**Standard Permit for Solid Waste Landfill
Granite State Landfill – Phase I
Response to NHDES Incomplete Application (#2021-52265)
Douglas Drive
Dalton, NH 03598**

**RE: Granite State Landfill, LLC
Proposed Lined Landfill – Dalton, New Hampshire
Standard Permit Modification – Application # 2021-52265
Response to NHDES Incomplete Application Correspondence**

Exploration Layout

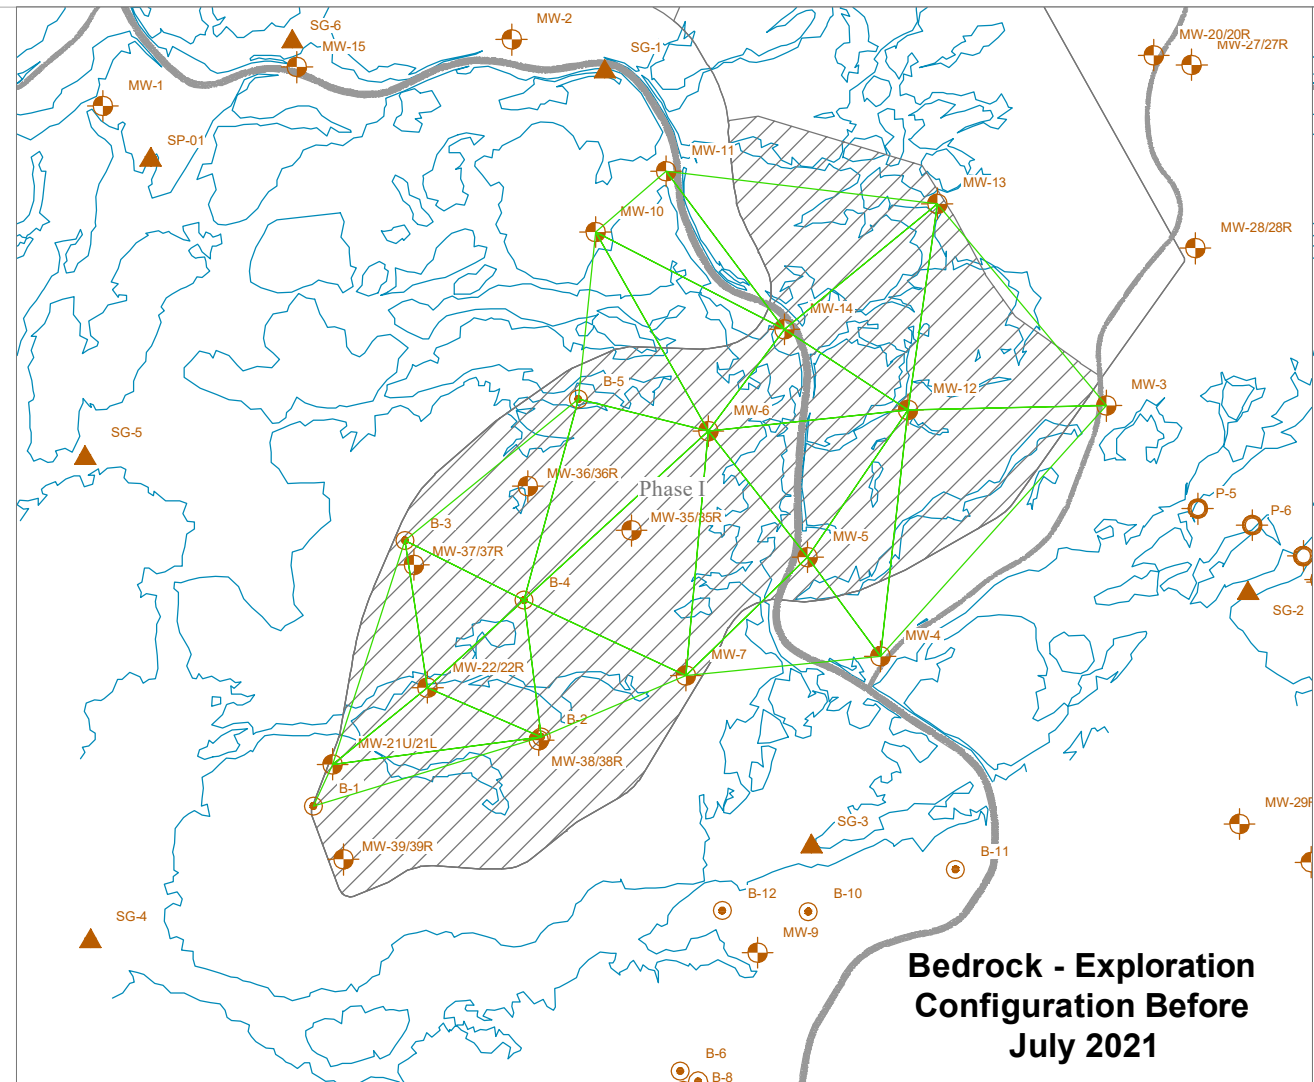
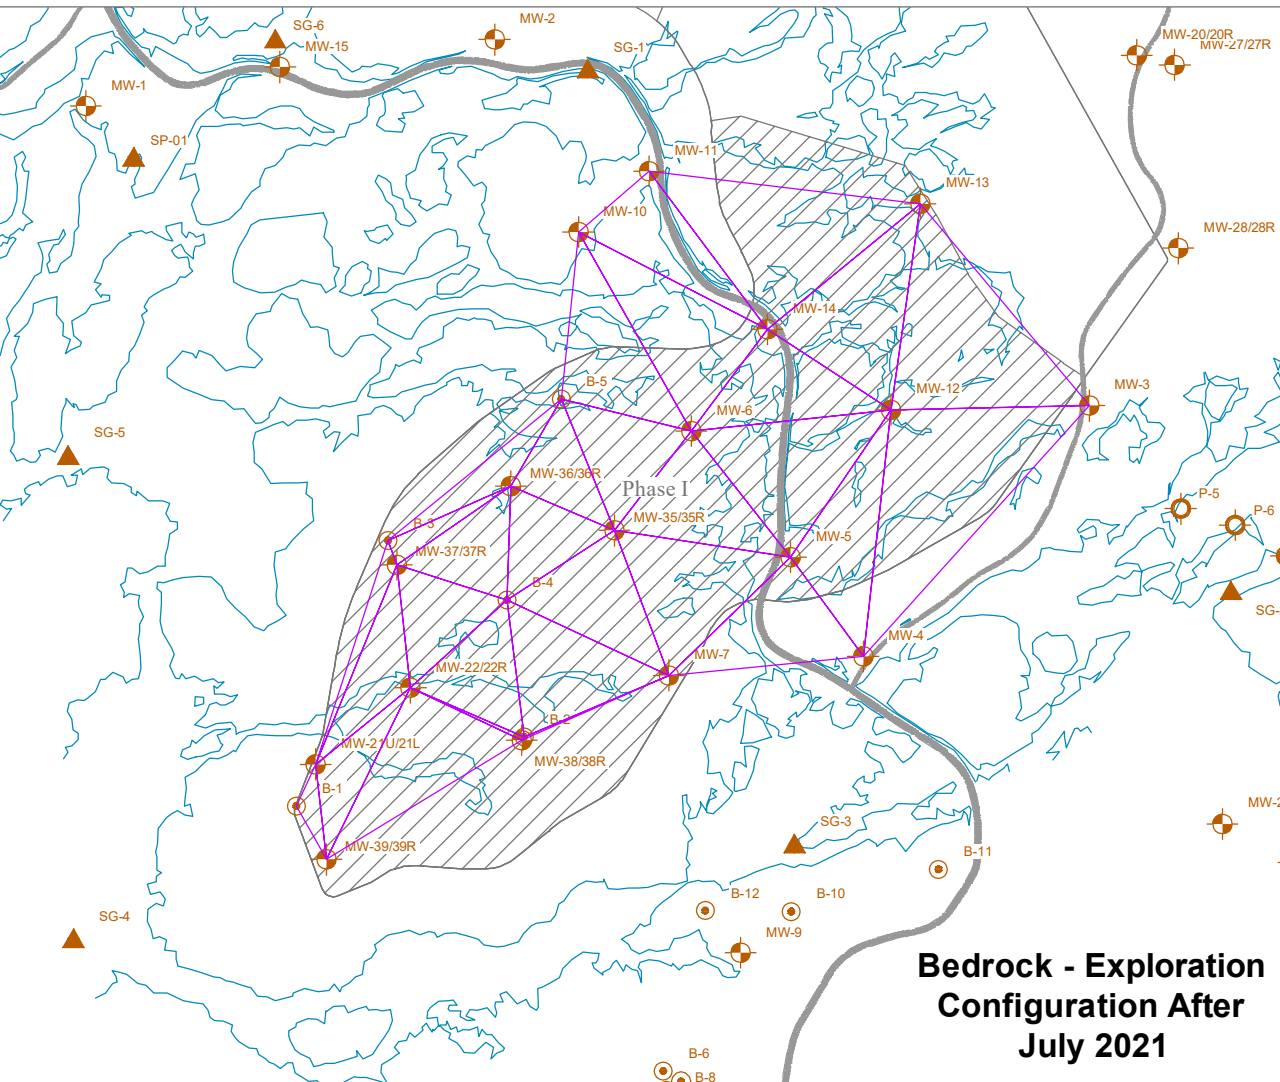
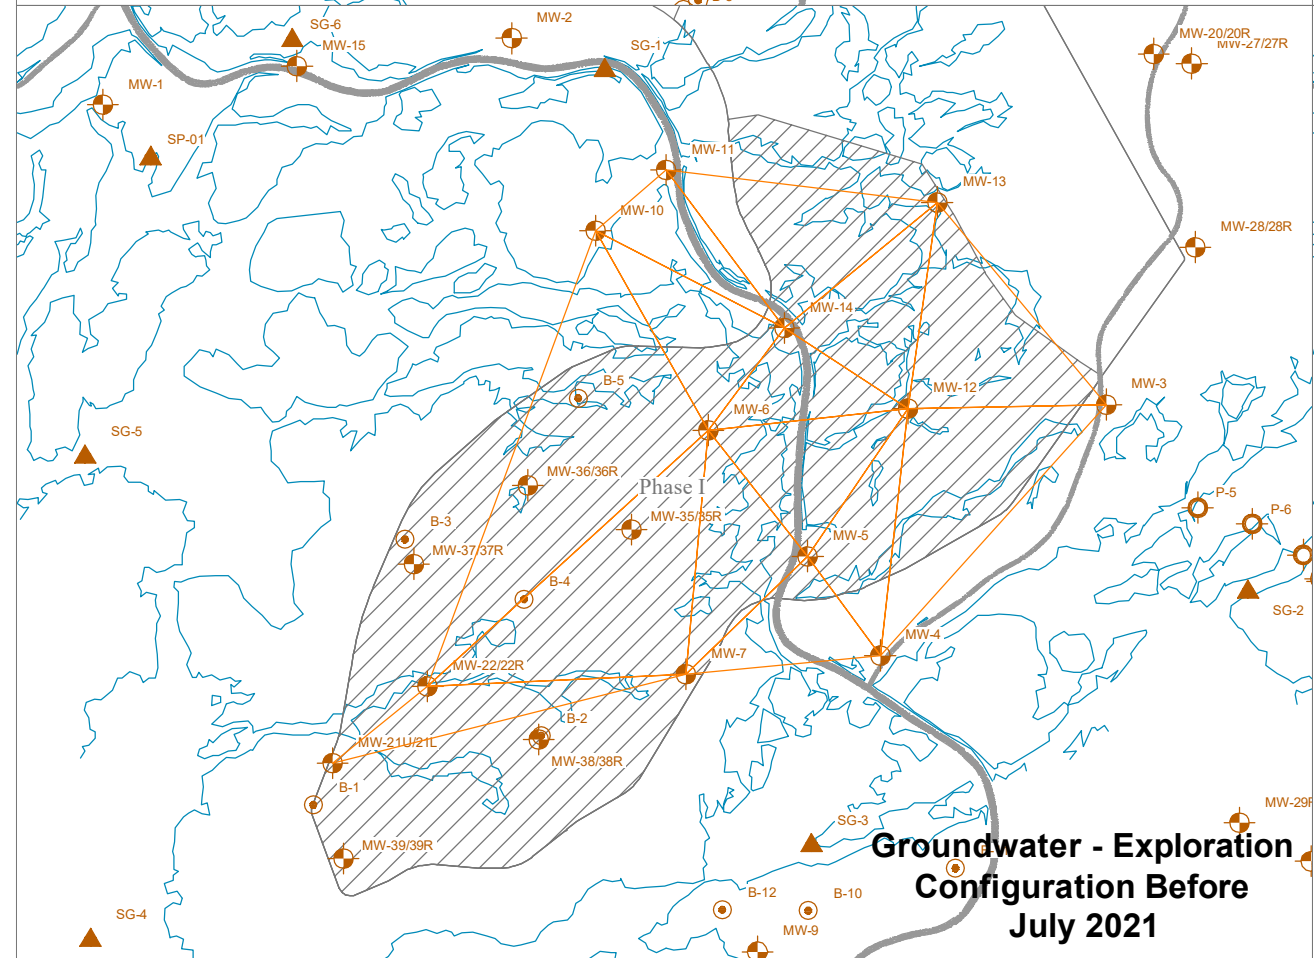
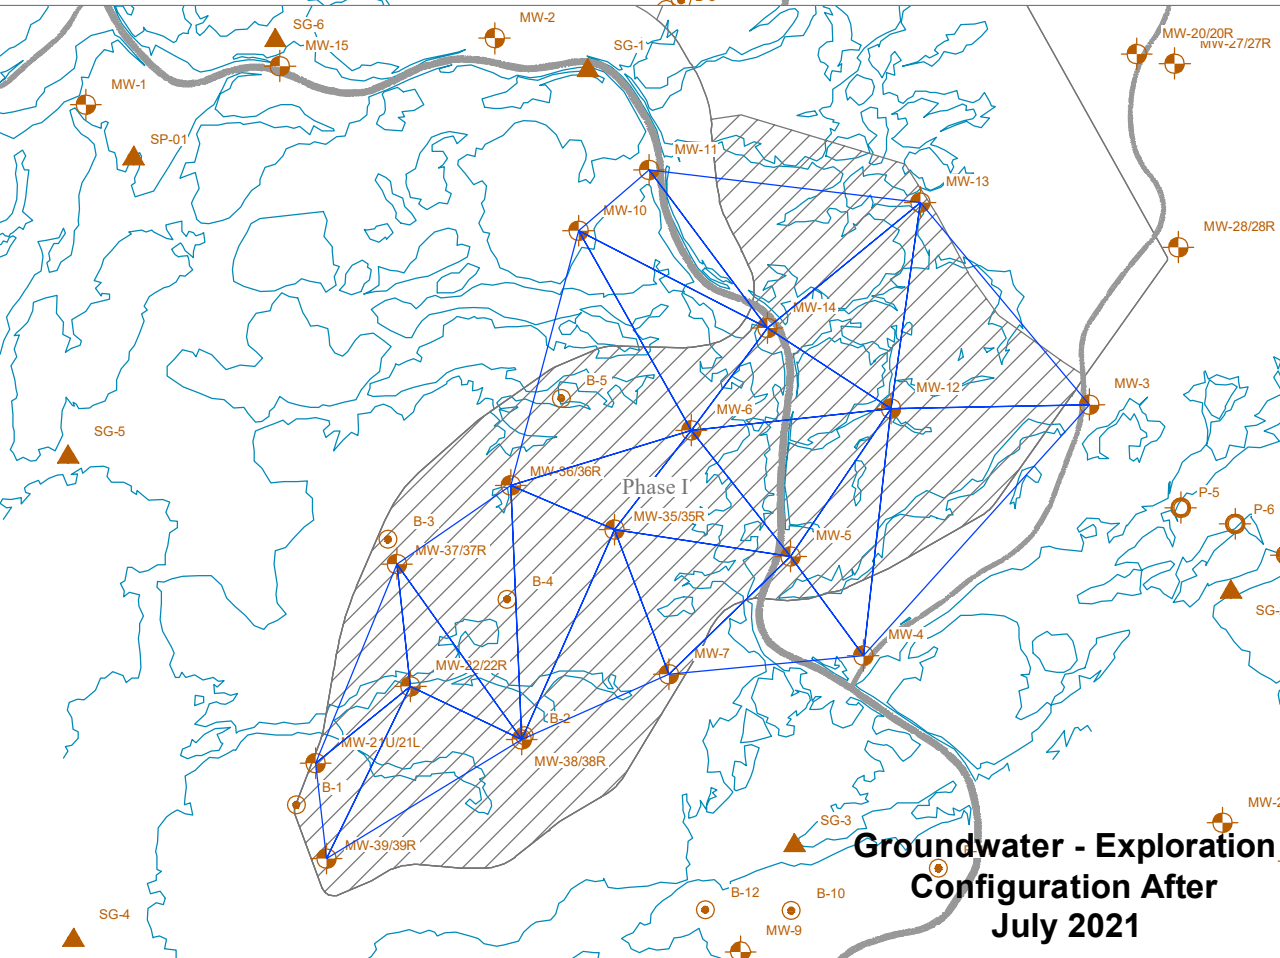
- *The logs of additional borings, laid out in a systematic investigative pattern within the footprint, used to determine depth to bedrock.*

As discussed with NHDES at the meeting on September 16, 2021, five monitoring well couplets were installed in the Phase I area in a systematic investigative pattern to provide additional bedrock and groundwater elevation information. The attached Hydrogeologic Supplement includes a site plan showing the locations of the borings sited in a systematic investigative pattern (Appendix A), as well as the boring/monitoring well completion logs (Appendix B).

As summarized on the attached sheet, the addition of new wells in July 2021 confirmed that interpretations of bedrock and groundwater table surfaces were being made over demonstrably shorter distances compared to the previous configuration, and allowed for greater “control” in interpreting between points. Boring locations are indicated on the attached Figure A.1; a summary of the refinements in point spacing includes the following:

Conceptual Seasonal High Groundwater Elevation Contour Plan

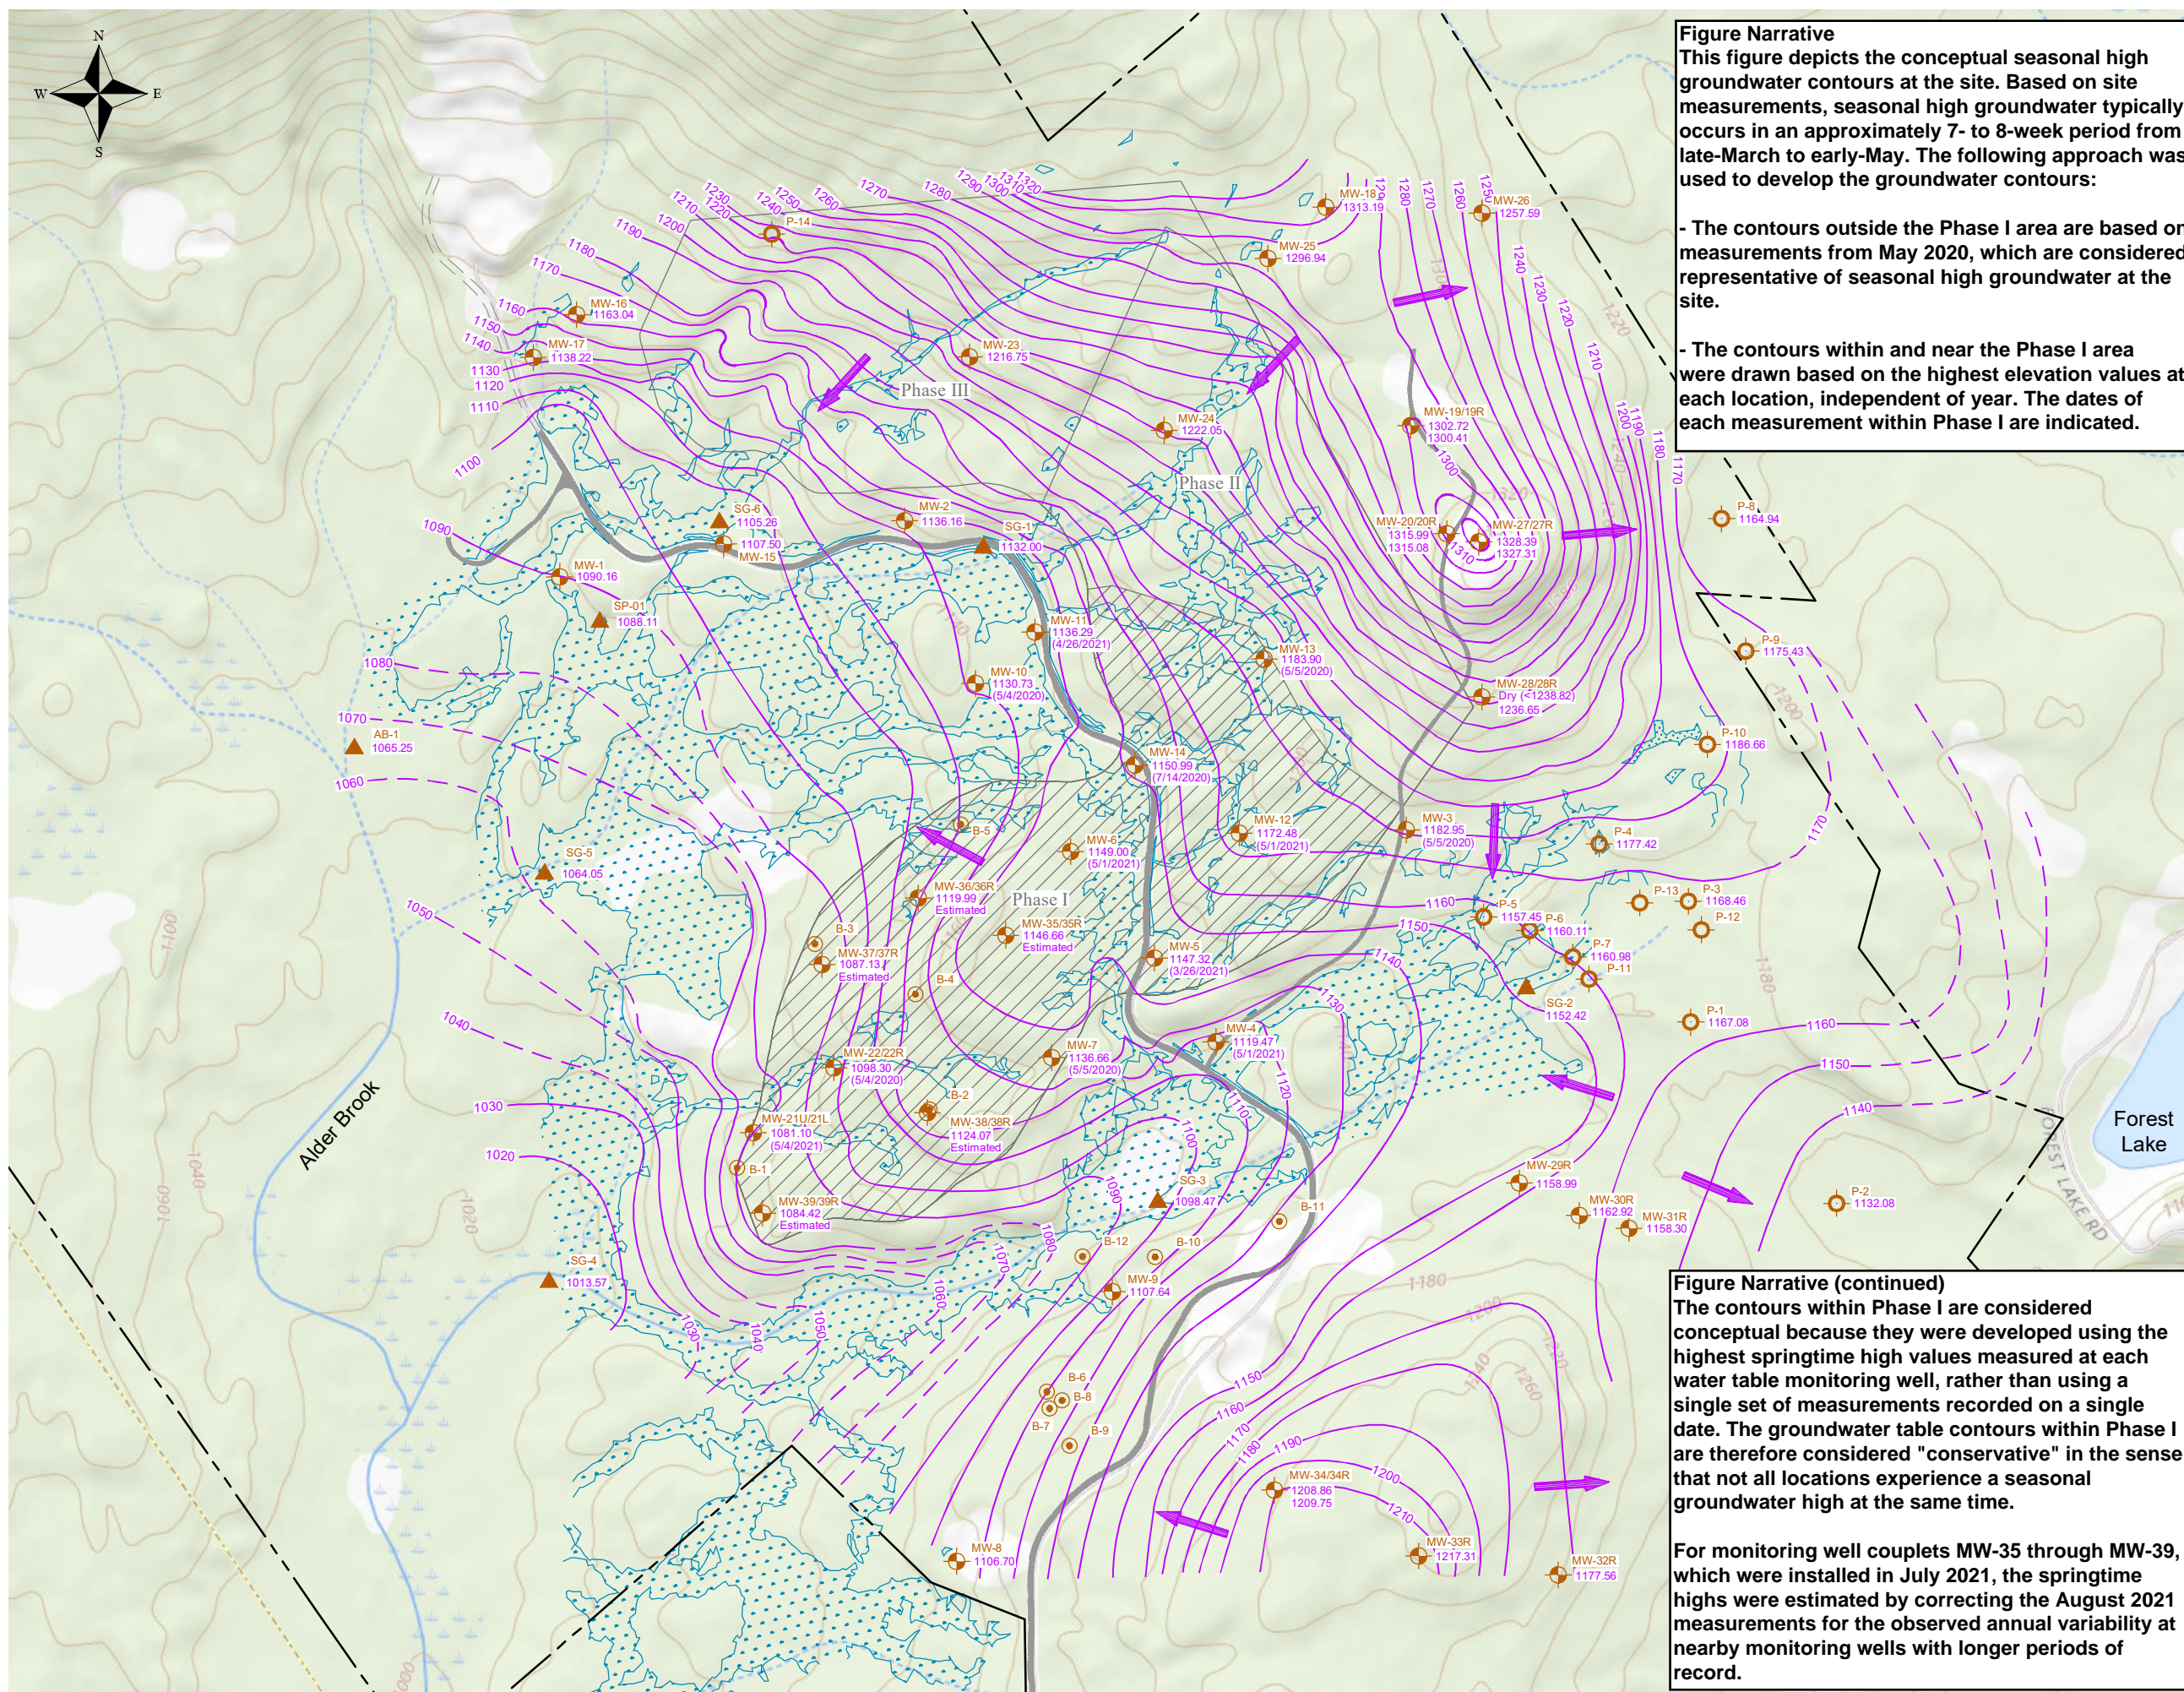
- *The logs and monitoring data from additional groundwater monitoring points, laid out in an investigative pattern within the footprint, used to evaluate seasonal high groundwater.*

As indicated above, logs of groundwater monitoring wells installed in July 2021 are included in the attached Hydrogeologic Supplement. Information from these borings and others previously installed at the site was used to evaluate seasonal high groundwater within the Phase I area (refer to Appendix C of the Hydrogeologic Supplement for a summary).

The contours within the Phase I area shown on Figure C.1 are considered conceptual because they were developed using the highest springtime high values measured at each water table monitoring well, rather than using one set of measurements recorded on a single date. The groundwater table contours within Phase I are therefore considered "conservative" in the sense that not all locations experience a seasonal groundwater high at the same time.
